# HISTORIC AND DESIGN REVIEW COMMISSION

May 05, 2021

**HDRC CASE NO:** 2021-182  
**ADDRESS:** 370 QUENTIN DR  
**LEGAL DESCRIPTION:** NCB 7026 BLK 5 LOT 23, E 43 FT OF 22 & W 4 FT OF 24  
**ZONING:** R-6, H  
**CITY COUNCIL DIST.:** 7  
**DISTRICT:** Monticello Park Historic District  
**APPLICANT:** San Antonio San Antonio/DOMINGUEZ ORLANDO & ALICIA  
**OWNER:** San Antonio San Antonio/DOMINGUEZ ORLANDO & ALICIA  
**TYPE OF WORK:** Fenestration changes  
**APPLICATION RECEIVED:** April 05, 2021  
**60-DAY REVIEW:** Not applicable due to City Council Emergency Orders  
**CASE MANAGER:** Rachel Rettaliata  
**REQUEST:**

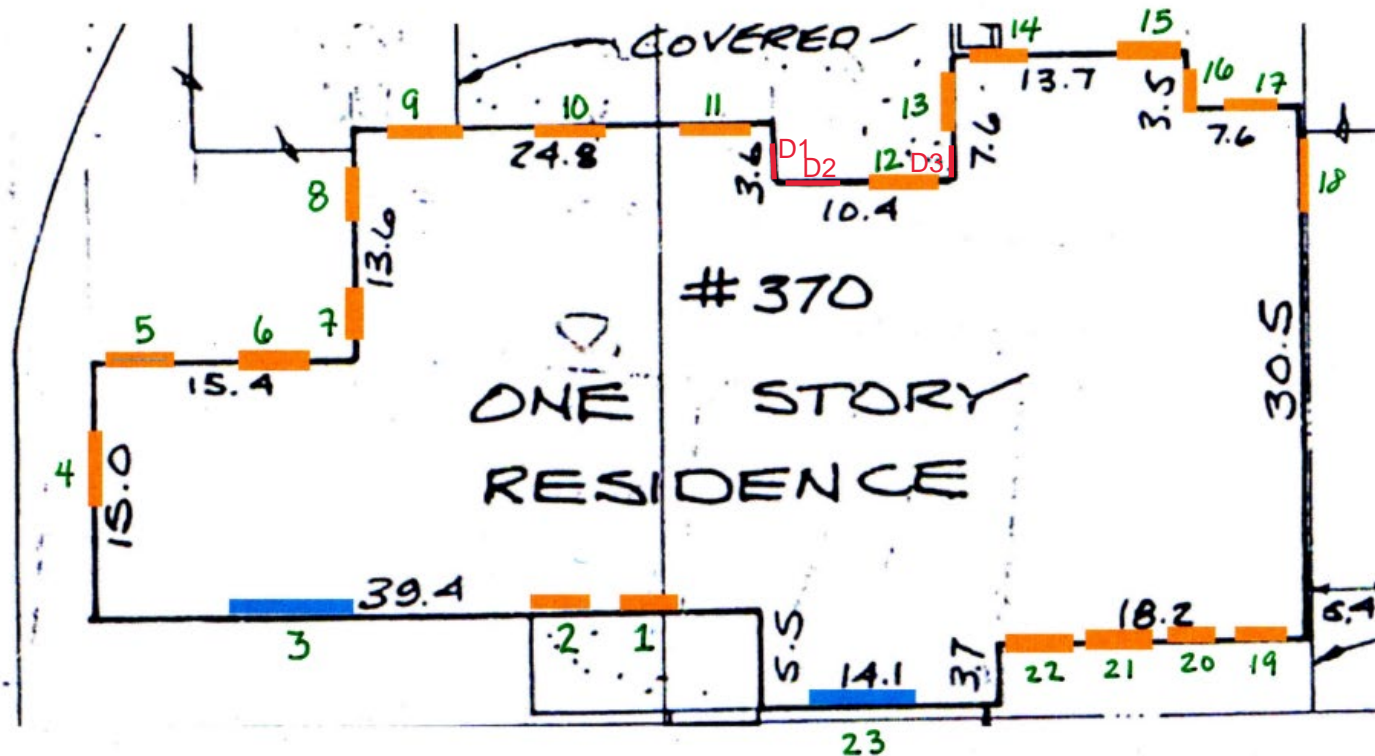
We would like to remove and enclose windows 13 and the adjacent door. The plan is to close off the wall for the purpose of installing base and overhead cabinets on the interior side. Neither window nor the door is believed to be original. The door is a metal door with blinds built into the glass. The window is not constructed like the other windows given no rope and weights are used.

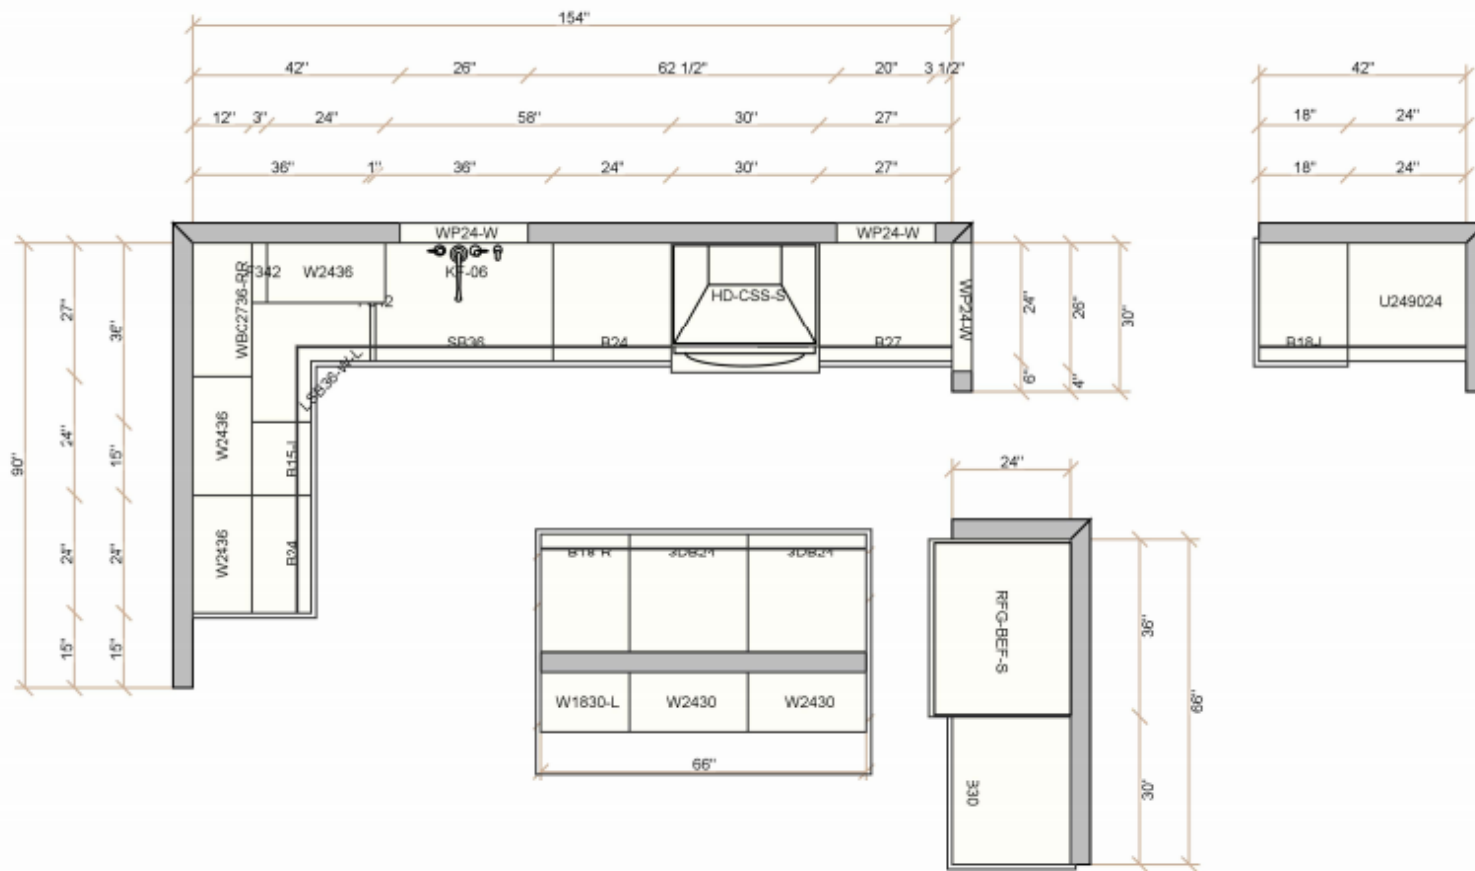
Window 14 will be resized and built of wood to match the existing windows. The plan is to install base cabinets and relocate the sink along the back wall. Window Windows 15 & 16 will be reconditioned to appear new.

We would like to remove and enclose windows 17 & 18. The plan is to create a laundry area. The washer and dryer are to go against the wall where window #17 exists. The sill of this window is 18" from the floor. Would like the washer and dryer vent, water and electrical source to be on this wall. Window #18 cannot be seen from the interior as the window along with the other wall is covered by wooden planks.

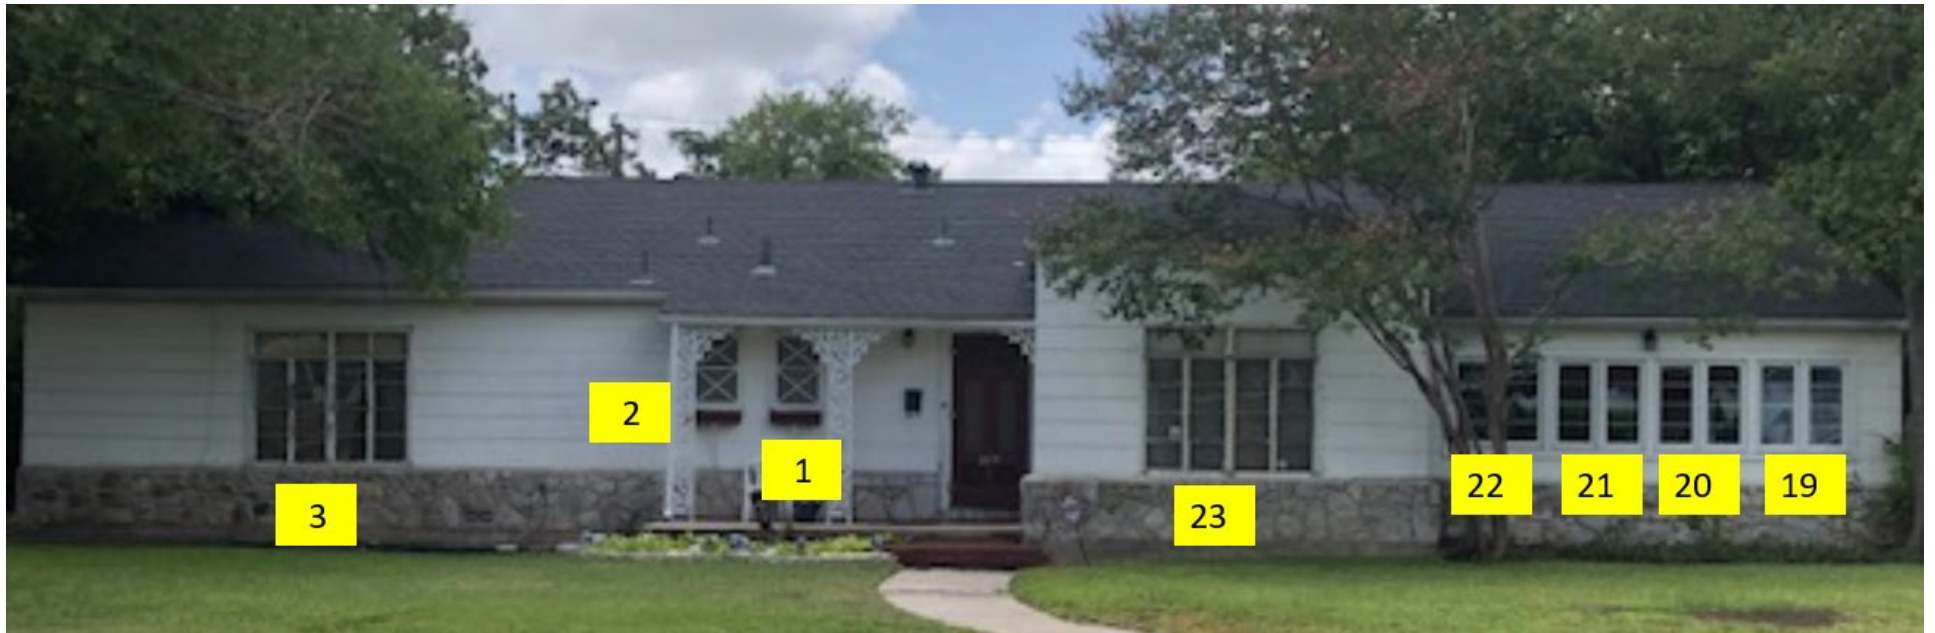
Would like to remove window #12 and the adjacent door and have it replaced with French doors. The doors in the rendering do not illustrate what we would like. We would like something similar to the one below the rendering, 72" x 80" steel door.

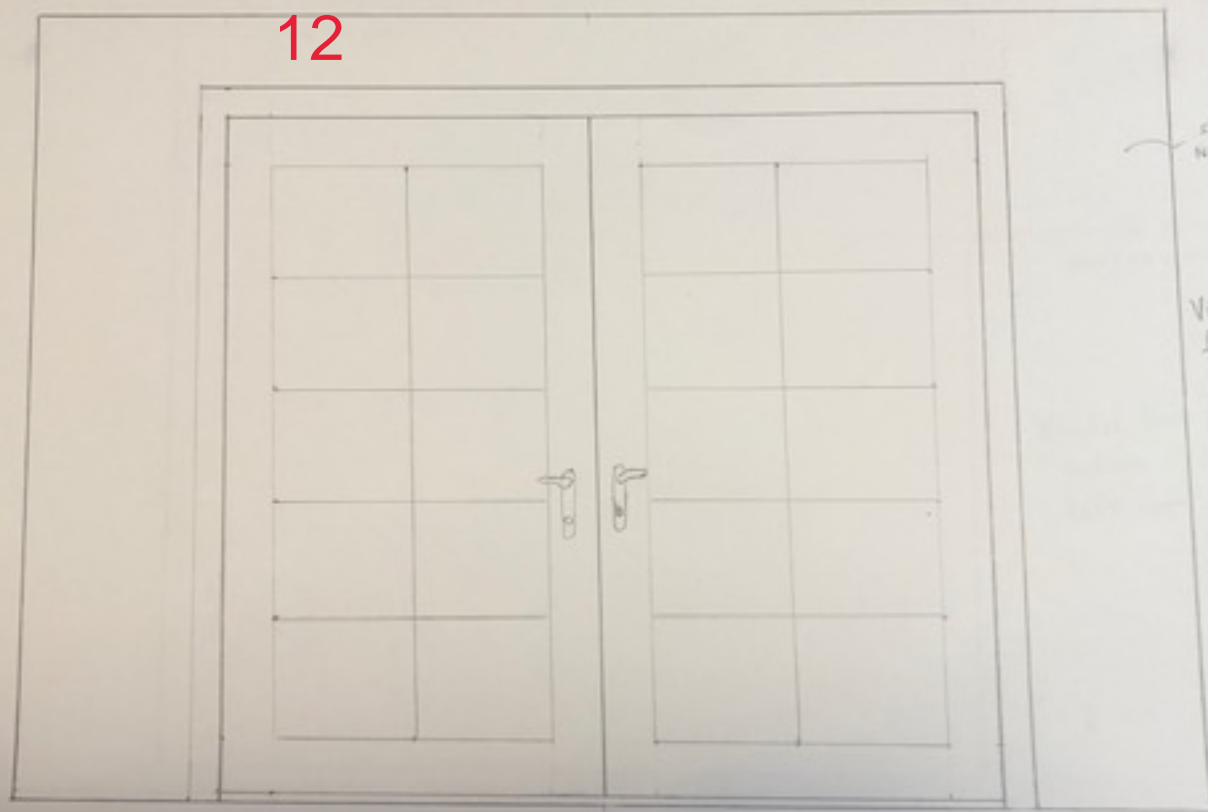
Window #13 on left and adjacent door. Would like to close up. Window on right is window #12.

Window #12 and adjacent door to be replaced with French door.

For reference purposes, a third existing door on the porch which is next to the adjacent door of window #12. Comment, I have no idea why anyone would place two doors that close to each other or why three doors would be needed for one porch.
